## Work Order ID 54018

Item Name: Basket Hoop

DESIGN #	DRAWN BY CP	DART AEROSPACE LTD HAWKESBURY, ONTARIO, CANADA	
CHECKED #	APPROVED #	DRAWING NO. D3166	REV. A SHEET 1 OF 1
DATE 02.07.10		TITLE BASKET HOOP	SCALE NTS
A	02.07.10	NEW ISSUE	
A1	04.04.08	38+/-1 WAS 36.0

DRAWING NO. D3166	TITLE BASKET HOOP	REV A1	DART AEROSPACE LTD ENGINEERING ORDER		D.E.O. NO. D3166-A-2	SHEET NO. 1 OF 1	SCALE NTS
DRAWN AJS	CHECKED 1	MFG. APPR. M	APPROVED M		DE APPR. H		
DATE 08.12.11	DATE 08.12.15	DATE 08/12/15	DATE 08/12/16		DATE 08.12.16

D3166-1 BASKET HOOP

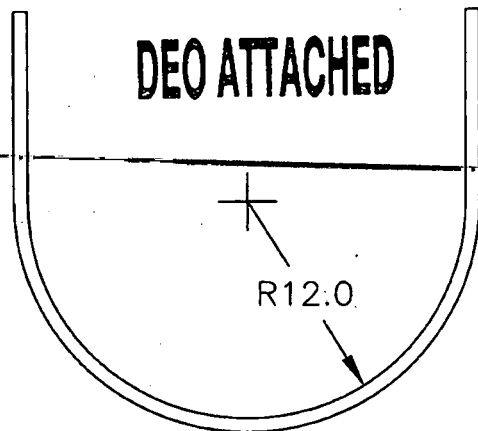
1) MODIFY MATERIAL NOTE FOR D3166-1 AS SHOWN:

1) MATERIAL: AISI 304/316 SS SQUARE TUBING,  
0.75" x 0.75" x 0.063 WALL, 60.00" LONG  
(REF DART SPEC. M304TS0.750W.063)

1) MATERIAL: AISI 304/316 SS, 3/4 X 3/4 X 0.065 WALL SQUARE TUBING,  
60.00" LONG  
REF. DART SPEC M304TS0.750W.065

D3166-3 BASKET HOOP

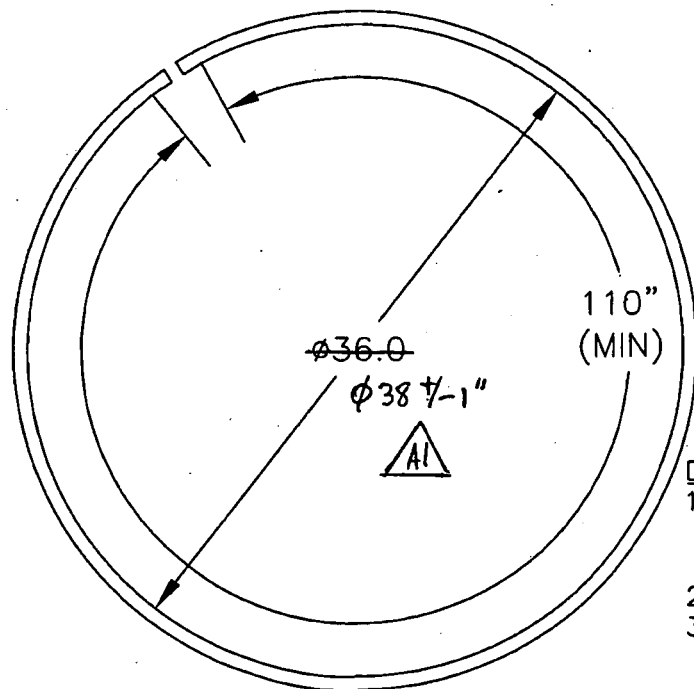
2) MODIFY MATERIAL NOTE FOR D3166-3 AS SHOWN:

1) MATERIAL: AISI 304/316 SS SQUARE TUBING,  
0.75" x 0.75" x 0.063 WALL, 120.00" LONG  
(REF DART SPEC. M304TS0.750W.063)

1) MATERIAL: AISI 304/316 SS, 3/4 X 3/4 X 0.065 WALL SQUARE TUBING,  
120.00" LONG  
REF. DART SPEC M304TS0.750W.065
